NOTICE OF PLANNING DEPARTMENT ACTION

<u>Application #</u>	PL-20-04645
<u>Subject</u>	Administrative Conditional Use Permit (CUP)
<u>Address</u>	7839 Hawk Court
<u>Description</u>	The Applicant is proposing retaining walls greater than six feet (6') in height within a Side Setback.
<u>Action Taken</u>	Approved
<u>Date of Action</u>	November 3, 2020

A NEW DESIGN FOR THE:
GREG & STACI RESIDENCE
 7839 HAWK CT
 PARK CITY, UT 84060

SITE PLAN

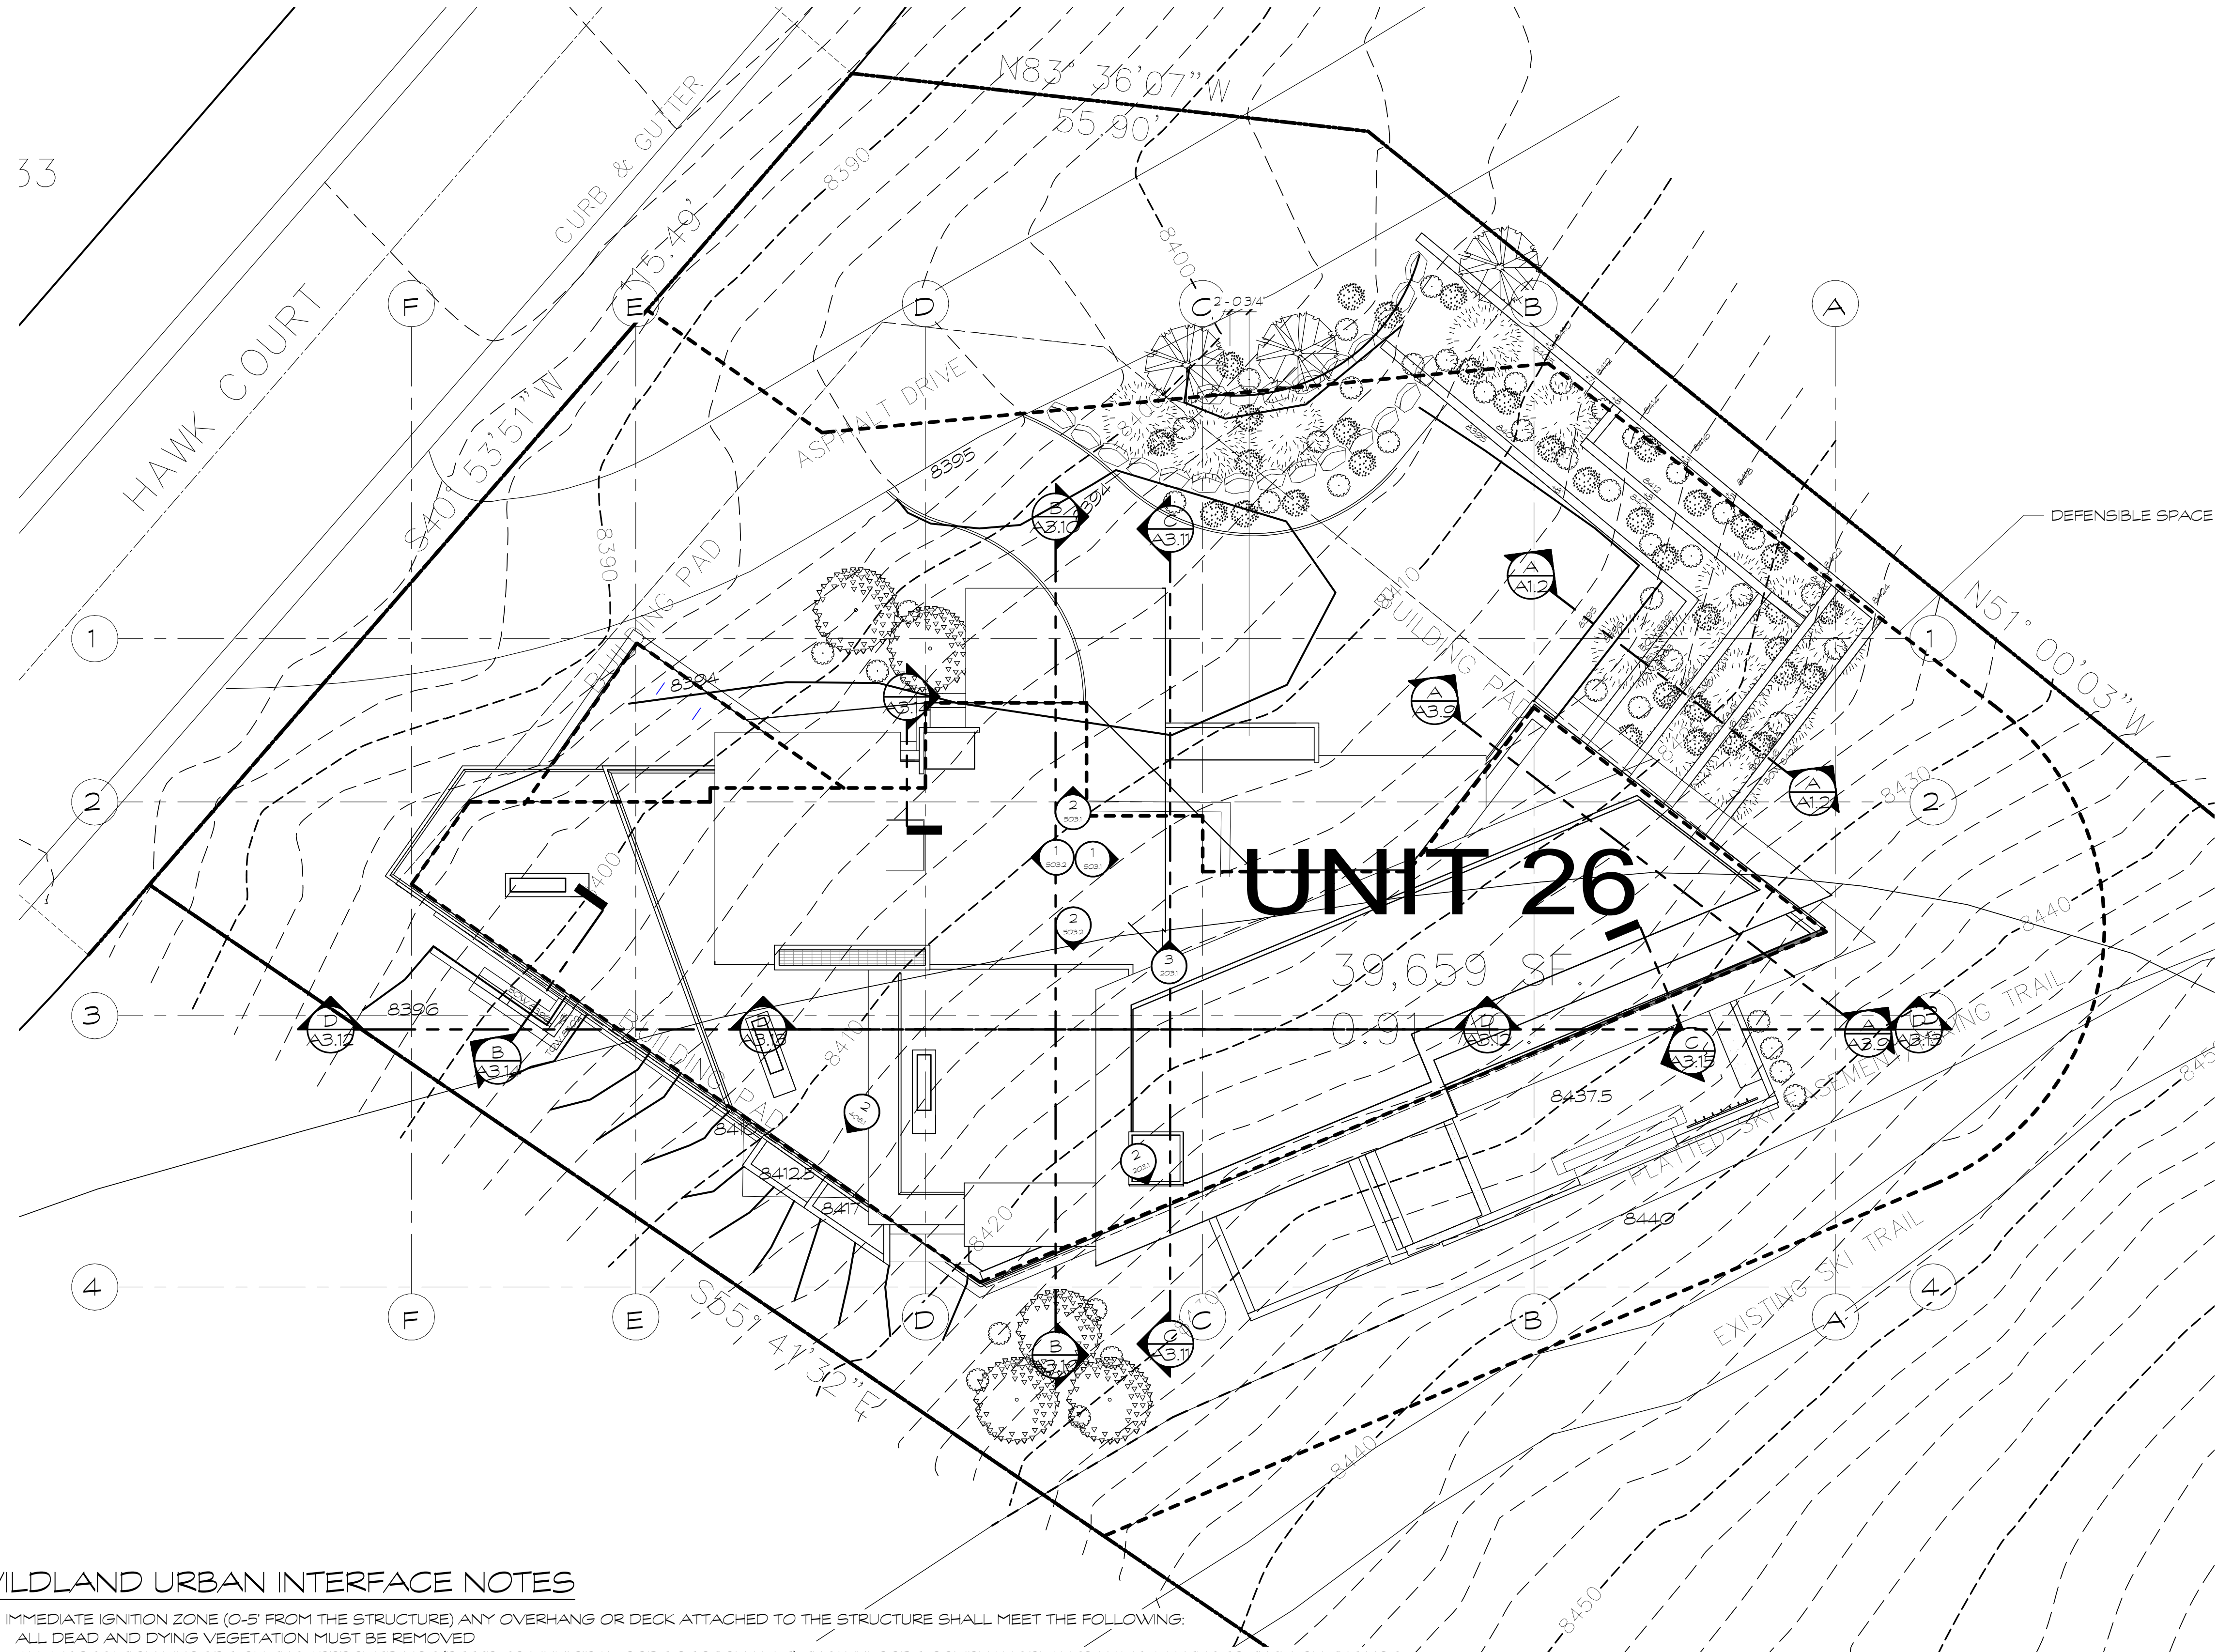
4. The proposed retaining walls shall match the plans submitted by October 29, 2020. See Exhibit A. Applicable walls are circled in red.
5. The public notice was posted and notice to adjacent property owners was sent on October 12, 2020. An Administrative Review of the Planning Director was held on October 22, 2020, which was open to the public. No written comments were given at this meeting, although an adjacent property owner was in attendance and submitted comments prior (Exhibit B). Public comments that were received were taken into consideration for this Determination.

3. The retaining wall shall be installed as approved on the plans submitted on October 29, 2020. Any stone shall be natural.
4. The retaining wall shall not violate applicable International Fire Code, International Building Code, and/or Park City Municipal Code.

6. Applicant shall comply with any Building Department process/procedures regarding obtaining proper authorization. For the Building Permit, the Applicant shall include a detail of the retaining wall design and profile stamped by a Structural Engineer. Walls may require a guardrail, per Building Code.
